APPENDIX B
Final
SECTION 4(F) EVALUATION

Golden Gate Bridge Physical Suicide Deterrent System Project
City and County of San Francisco and County of Marin, California

Project 2006-B-17
04-MRN-101-GGHT
Federal Project #: STPL-6003(030)

FIGURE 3
SECTION 4(f) RESOURCES: MARIN APPROACH

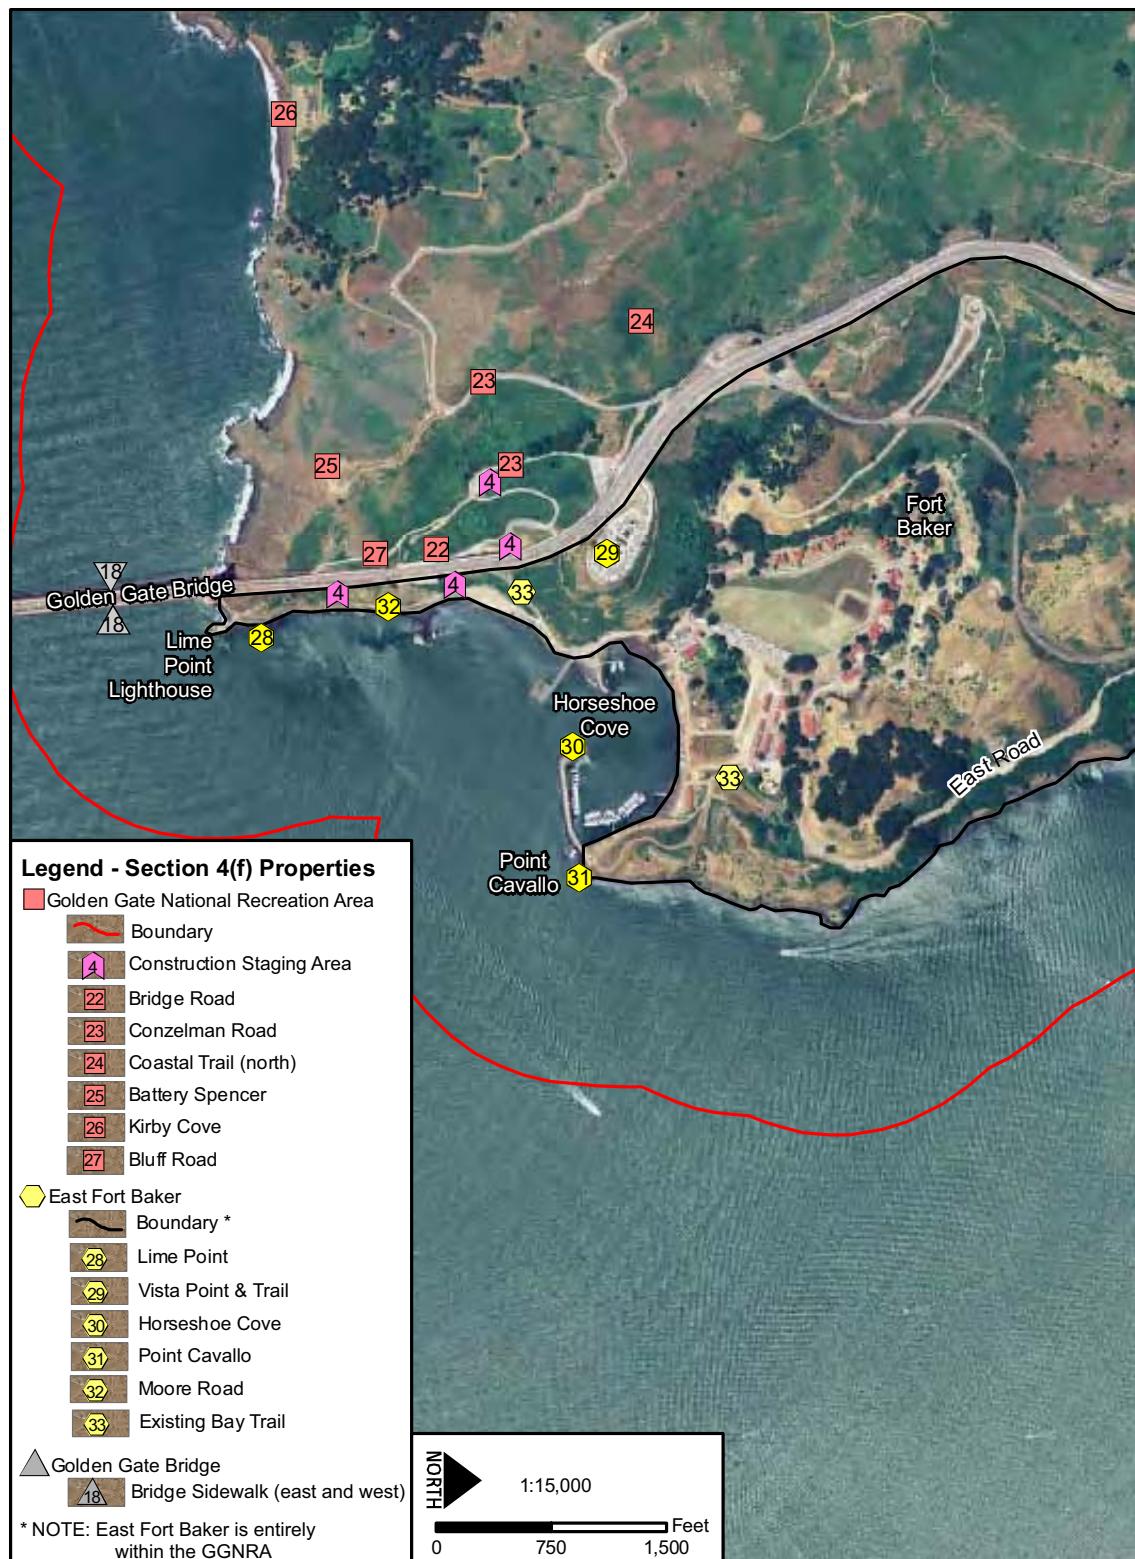
10. Figure 2.1-2 Correct GGNRA offshore boundary. Show Fort Baker as part of GGNRA. 1j
11. Show Construction Staging Areas (item 4) in a separate color and symbol. 1k

The United States Department of Interior, GGNRA requests a correction be made to Figure 2.1-2 to show the legislative boundary of the GGNRA and to show all of East Fort Baker as part of the GGNRA. The commenter also requested that construction staging areas shown on this figure have a distinct color and symbol.

Figure 2.1-2 has been updated accordingly; see page 2-4 and Appendix B, page 11, of the Final EIR/EA.
